State of Wisconsin \ DEPARTMENT OF NATURAL RESOURCES

DNR File No. DC-0121

Subject: Amendment to the *Dane County Water Quality Plan*, Revising the
Central Urban Service Area Boundary and Environmental Corridors in the
Hornung Range portion of the City of Madison and Town of Burke.

Map 1
 Amendment to the
 Central Urban Service
 Area and Environmental
 Corridors in the Town of
 Burke & City of Madison

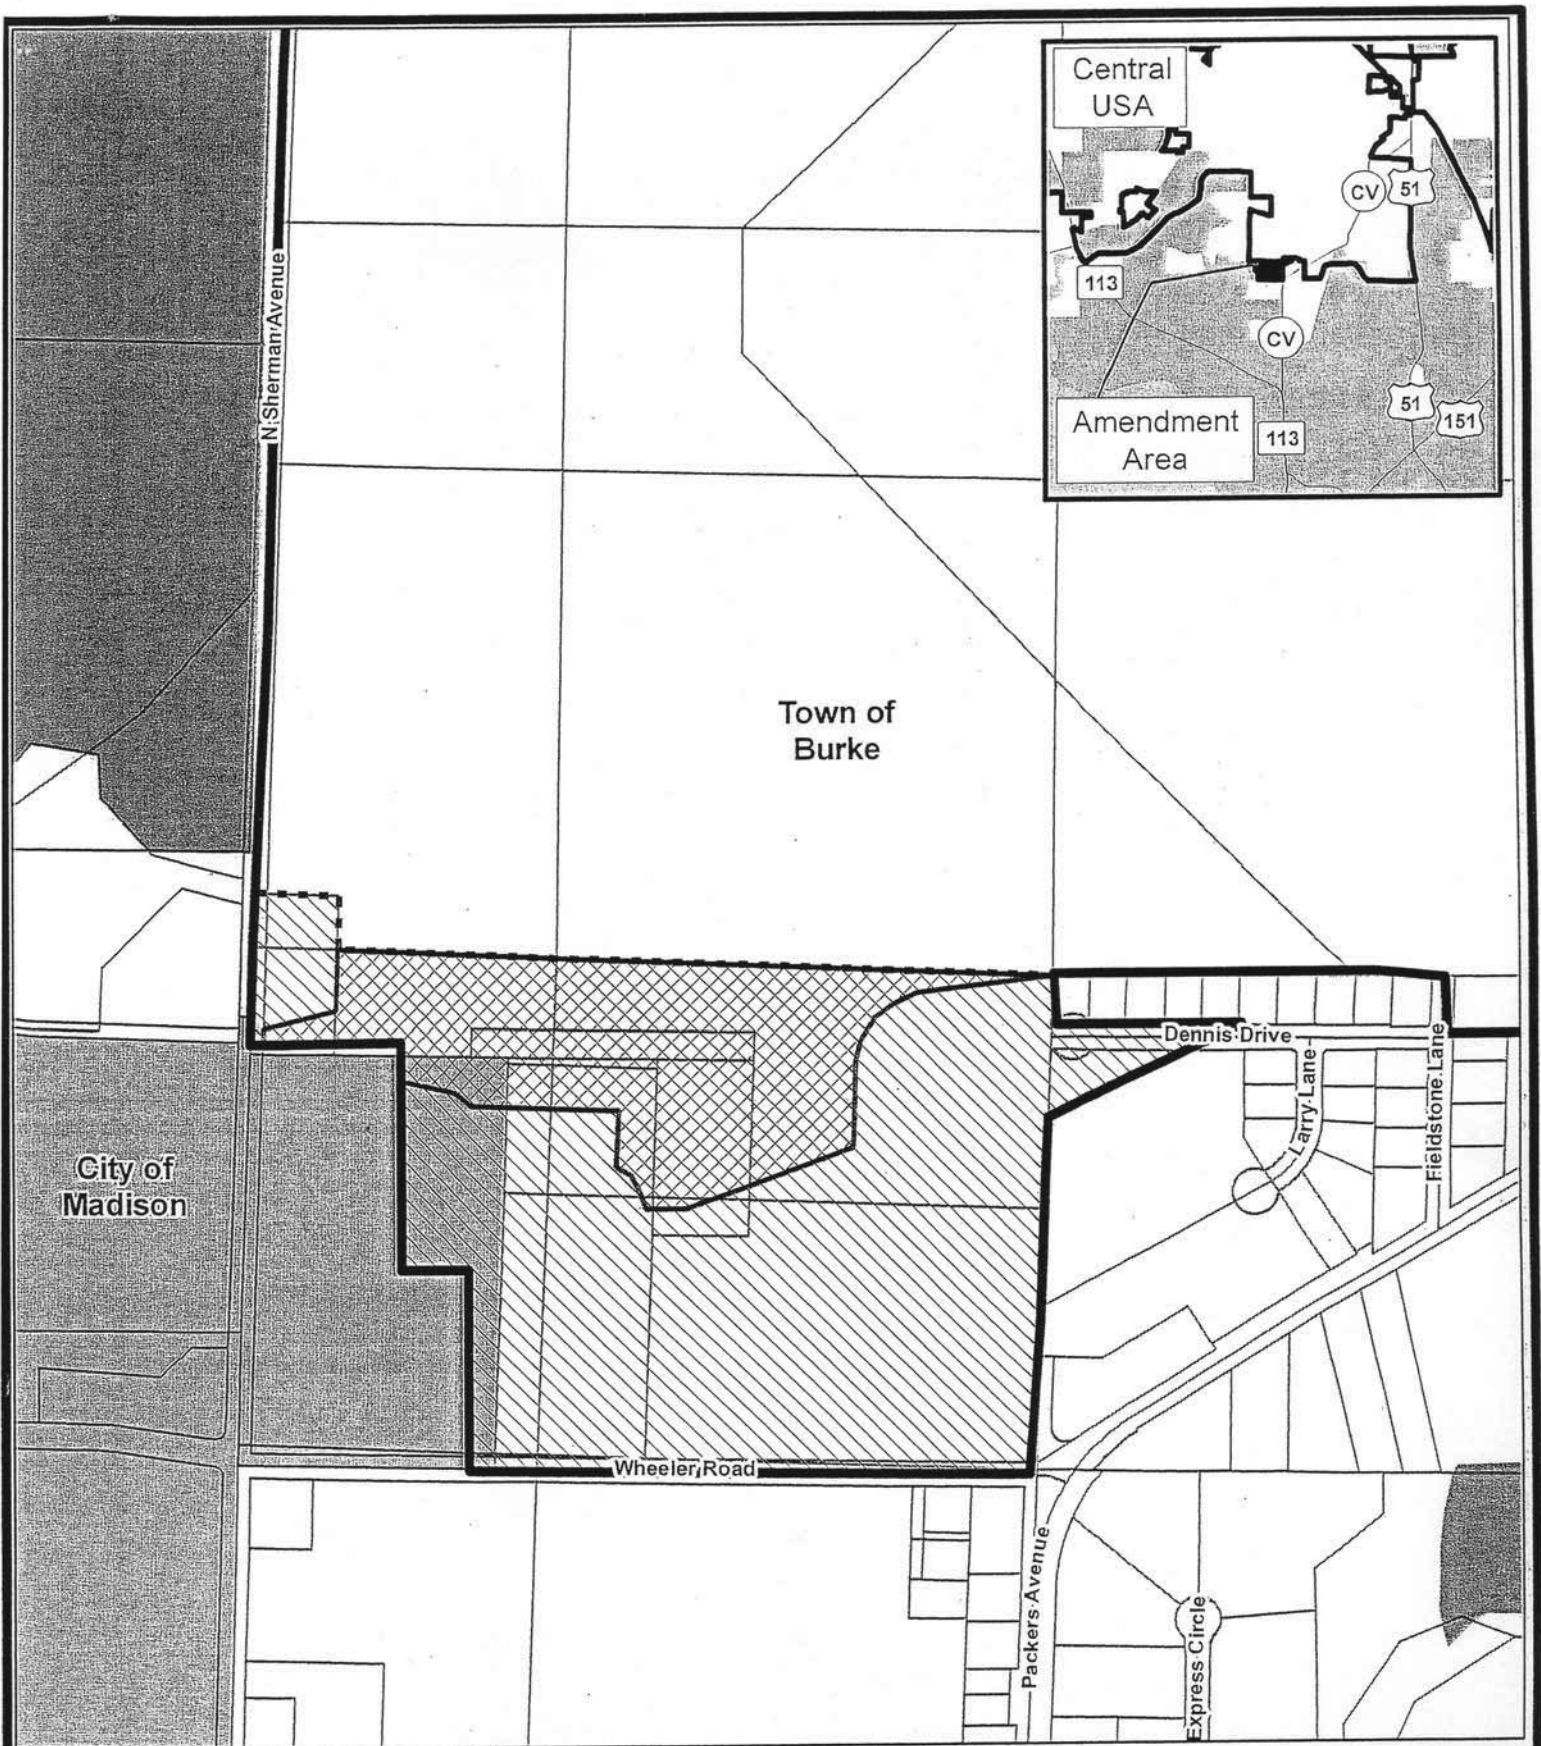
We have completed our review of the subject amendment request that was submitted to the Department on July 7, 2008 by the Capital Area Regional Planning Commission. The Department hereby approves this amendment request which adds 55.8 acres to the Central Urban Service Area, including 14.7 acres of existing development and 15.8 acres of environmental corridors, with a net developable area of 25.3 acres. The amendment area is contiguous with the northern part of the service area and is located north of Wheeler Road and east of Sherman Avenue (See Map 1).

This Department approval is subject to the condition that the City of Madison comply with all the conditions stated in Resolution CARPC No. 2008-15 regarding a stormwater management plan, in addition to the following conditions:

1. Work with the Wisconsin Department of Natural Resources' Bureau of Endangered Resources to identify needed protective measures for threatened and endangered resources near the amendment area, and implement these protective measures as part of site design (including increased buffers if necessary).
2. Maintain wetland buffer areas as no-mow, no fertilizer, no pesticide zones with native vegetation (prairie grasses) within 75 feet of the wetland edge to prevent discharge of nutrients into the Marsh.
